**The State of New Jersey
Department of Environmental Protection**

**State Implementation Plan (SIP) Revision for
the Attainment and Maintenance of the
Fine Particulate Matter (PM_{2.5}) National Ambient Air Quality
Standards**

**Final
Redesignation Request and Maintenance Plan
For
Annual 15 µg/m³ and Daily 35 µg/m³
PM_{2.5} National Ambient Air Quality Standards**

**Appendix XI
Public Participation and Response to Comments**

Figure 1
PM_{2.5} Design Value Concentrations, Annual Design Values 1999-2011
New Jersey Statewide

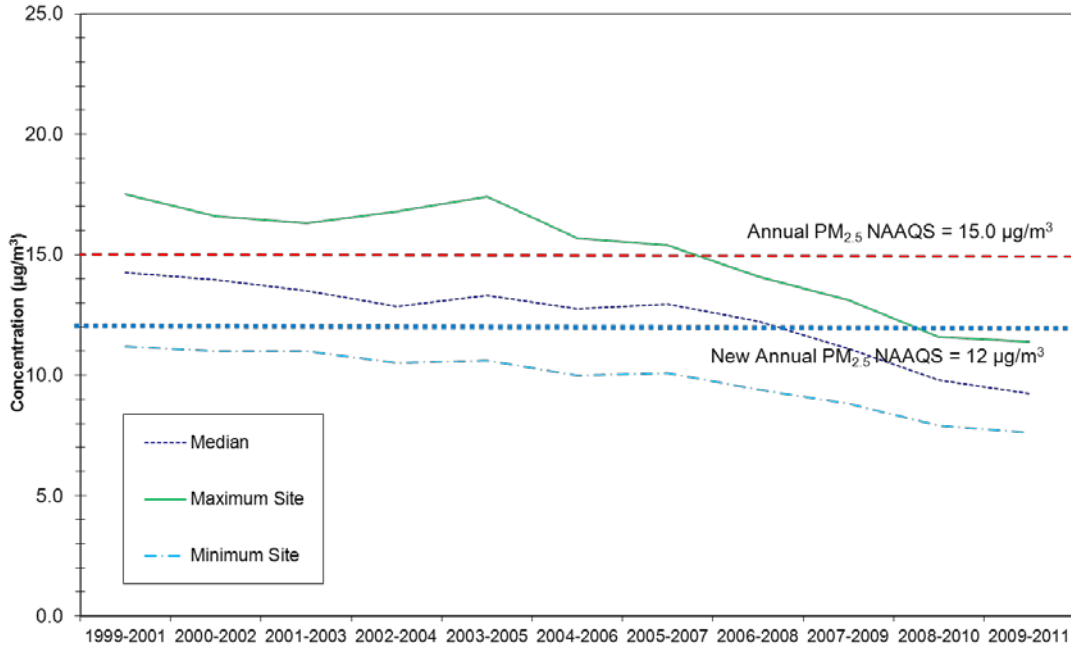
12. **Comment:** The State is only using data from the past two years to make our air appear on paper cleaner than it really is. There has been no overall improvement in New Jersey's air quality. NJ Sierra Club
13. **Comment:** The State should retain its nonattainment status for PM_{2.5} until such time more data, over a longer period of time, can be collected. Ana Baptista, ICC

Response to Comments # 12 and 13: The commenter is incorrect, there has been improvement in New Jersey's air quality and it has been demonstrated over a period longer than two years. The multi-state PM_{2.5} trends graphs in Figures 3 through 6 of the SIP show overall decreasing trends, with sharper declines in the 2005-2007 design value range. New Jersey state specific trends graphs are shown below in Figures 1 and 2.

As shown in the New Jersey statewide graphs, the sharper decline begins in the 2003-2005 design value range.

Figure 3

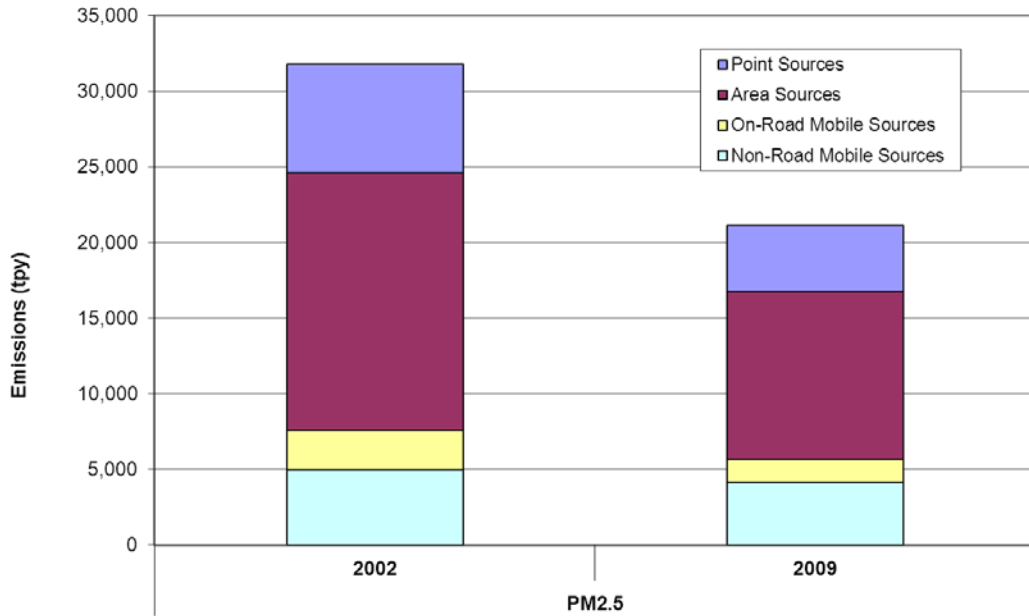
19. **Comment:** We contend that you have not met the basic USEPA requirements that demonstrate that the improvements in air quality are due to permanent and enforceable reductions in emissions of PM_{2.5} or its precursors. There is little evidence presented to back up claims of pollutant reductions due to some of the listed measures for the reduction period of 2007 -2009. Almost half of the measures indicated in Table 1 (11 of the 23 measures) were implemented in 2009 and beyond and thus do not account for the stated reduction of PM levels from 2007-2009 for both the daily and annual PM design values. We believe you have not presented sufficient evidence to suggest a "trend". The decrease below threshold levels begins only around 2007-2009 (Figures ES.5 through ES.8) over the course of more than ten year's worth of data. This pattern that begins in 2007 also coincides with the start of a widespread economic recession and what you are interpreting as a trend may in fact be a temporary dip rather than a consistent pattern of decline based on any strong policy implementation from the State. Your analysis of past trends do not consider the potential relative impact of different economic scenarios under which policies that drive decreases in emissions might be offset by increased economic activity from various sectors in the region. The decrease of PM_{2.5} from the period beginning in 2007-2009 may have more to do with regional and national economic downturn than any proactive, enforceable strategies emanating from the State. The idling rule and the energy master plan are of minimal or no contribution to emission reductions.

21. **Comment:** The Redesignation Request does not address, in any manner, the concern that a significant portion of recent reductions in $PM_{2.5}$ concentrations are due to the country's economic recession and therefore are not permanent or under the control of the State. Concentrations generally show a declining trend from 1999 until 2000-02, 2001-03, or 2003-05, then level off and decline again. This second decline could at least partly be due to the recession. If the decline in $PM_{2.5}$ concentrations is partly due to the economic recession then it is not permanent or enforceable. The commenter suggests the State gather monitoring data during, and subsequent to, an economic recovery that demonstrates New Jersey $PM_{2.5}$ concentrations are below Federal standards. Nicky Sheats, NJEJA

Response to Comments # 19 through 22: The declining trend in $PM_{2.5}$ in the ambient air is due to permanent and enforceable control measures as discussed in the SIP. While the economic recession may have played a part in emission decline, the decrease in emissions from control measures far surpasses the economic recession decline as discussed in detail below.

Figures 3, 4 and 5 below show New Jersey's emission inventory trends from 2002 to 2009 for $PM_{2.5}$, NO_x and SO_2 .

As shown in the figures, PM_{2.5} emissions are estimated to have decreased from 2002 to 2009 by 34 percent, NO_x emissions are estimated to have decreased by 39 percent and SO₂ emissions are estimated to have decreased by 70 percent.

Figure 6
Emissions Reported To The Emission Statement Program
"Stationary Sources"

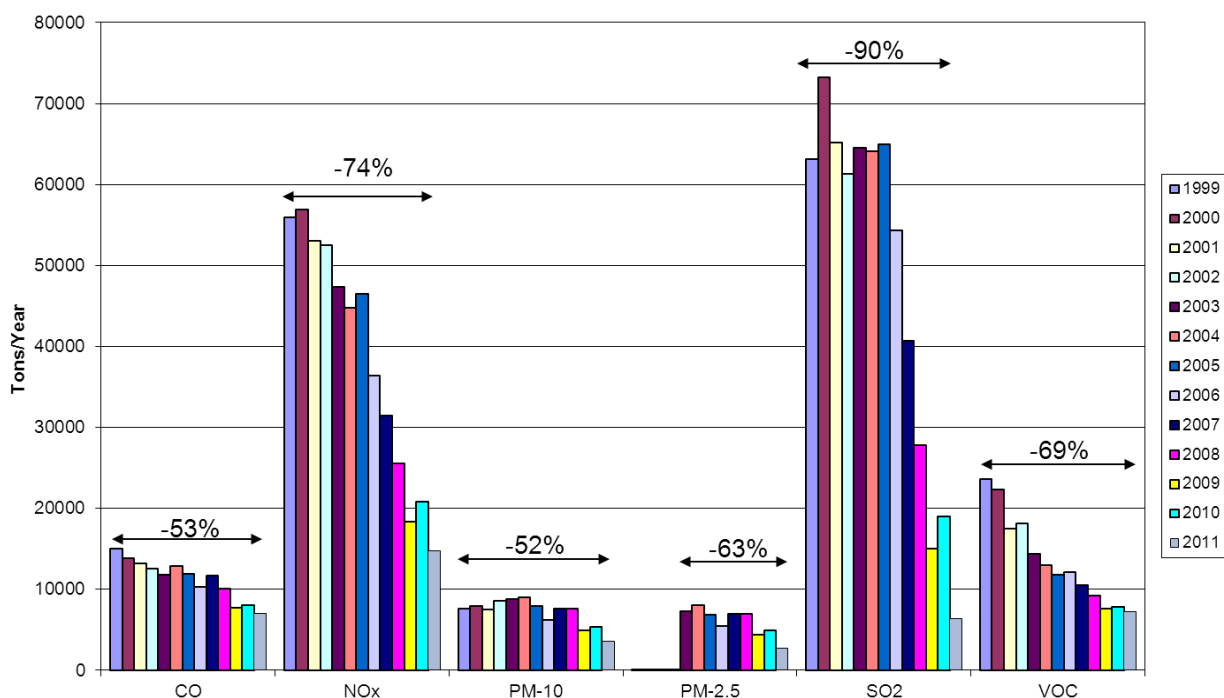
22. **Comment:** The Sierra Club has concerns with the request to redesignate the nonattainment areas in New Jersey for fine particulate matter ($PM_{2.5}$) to attainment based on decreased emissions based on decreased energy use. During the last two years people have been driving less due to unemployment, businesses have been using less energy and facilities have not been running at full capacity, resulting in less air emissions. More people have been taking mass transit because of the recession with PATH having a record year. High energy costs have led to a reduction in energy across sectors. NJ Sierra Club

A graph summarizing the emission reductions in the point source sector is shown below in Figure 6. Significant decreases in PM_{2.5}, SO₂ and NO_x are shown in this graph, as well as VOC, CO and PM₁₀.
